CENTERVILLE PLANNING COMMISSION AGENDA

NOTICE IS HEREBY GIVEN THAT THE CENTERVILLE PLANNING COMMISSION WILL HOLD ITS REGULAR PUBLIC MEETING AT 7:00 PM ON April 9, 2014 AT THE CENTERVILLE CITY COMMUNITY CENTER AND CITY HALL COUNCIL CHAMBERS, 250 NORTH MAIN STREET, CENTERVILLE, UTAH. THE AGENDA IS SHOWN BELOW.

Consideration of an amended final site plan for The Pasture Business/Industrial Park; which consists of changes to a rock wall, landscaping and entryway features, to be located at approximately 1275 North 1300 West

**STAFF REPORT
AGENDA: ITEM 2**

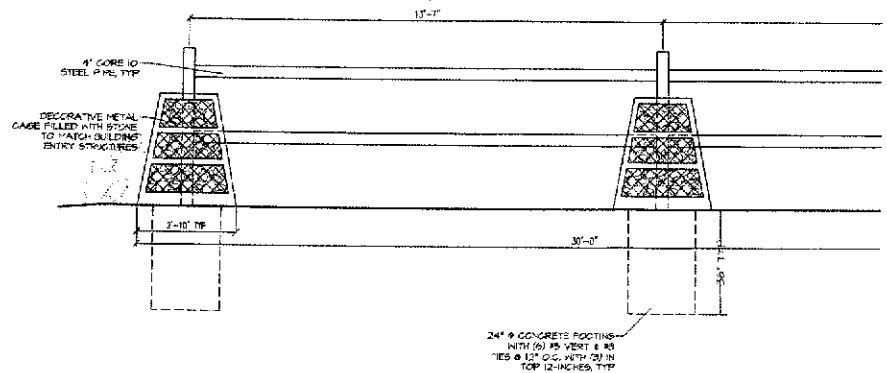
- The wall is proposed to be more of a straight upright wall then originally planned

- The timbers will still be a decorative feature in the wall, just placed in the front.

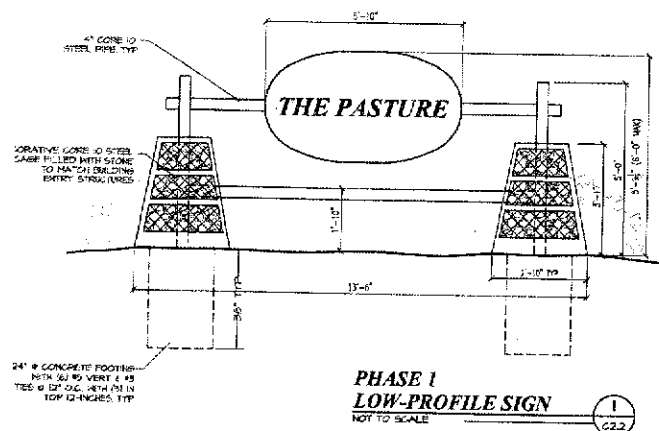
- The Bridge feature will consist of metal cages filled with rocks and Core 10 Steel pole rails.

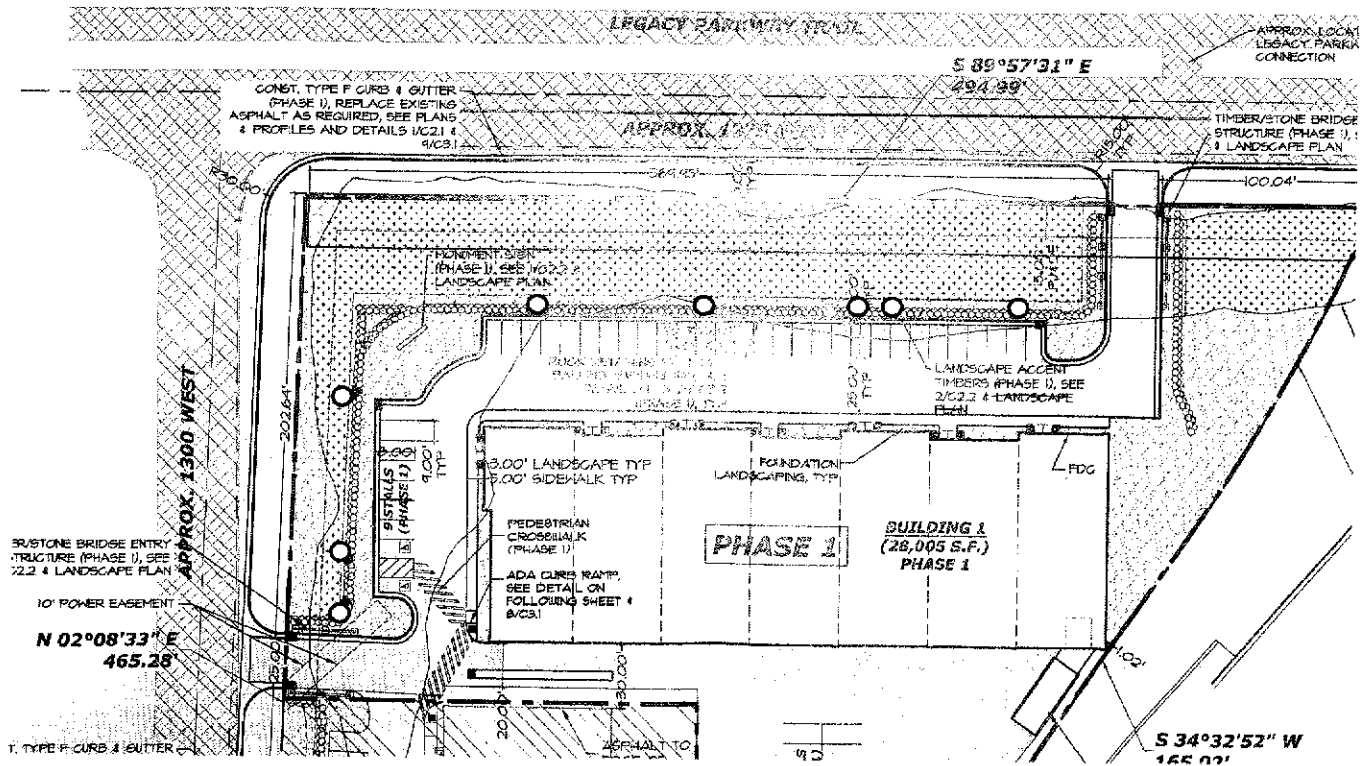
- A landscaping plan was submitted prior to the amendment and has not changed in style and type of plantings. Staff is accepting of the landscaping plan and will require the applicant to adhere to what was approved at the original final site plan approval on April 25, 2013. The plantings must be integrated around the rock wall to add a natural variety.
- All driveways have been extended as to have 25 feet of drive isle width, plus additional space for the bridge feature
- The front corner of the rock wall has been modified as to create a stepping from the wetland area to the parking lot

- The front timbers have been interspersed along the front wall and appear to be even intertwined with the wall (Timber feature is indicated by the yellow markers).

2. The applicant shall follow the approved landscaping plan as per the original final site plan approval dated April 25, 2012
3. The timbers and landscaping shall be placed as to appear random and natural, rather than formalized.
4. The applicant shall reconstruct the front corner of the wall to create a stepping design up toward the project signage. This rock wall detail shall allow for more variety of appropriate Shorelands Commerce Park vegetation to be planted.
5. All signage shall require a separate permit
6. Applicable bonding shall be posted and all professional service fees shall be paid
7. The applicant shall continue to work with the City Engineer concerning culverts, drainage issues and other related engineering issues.
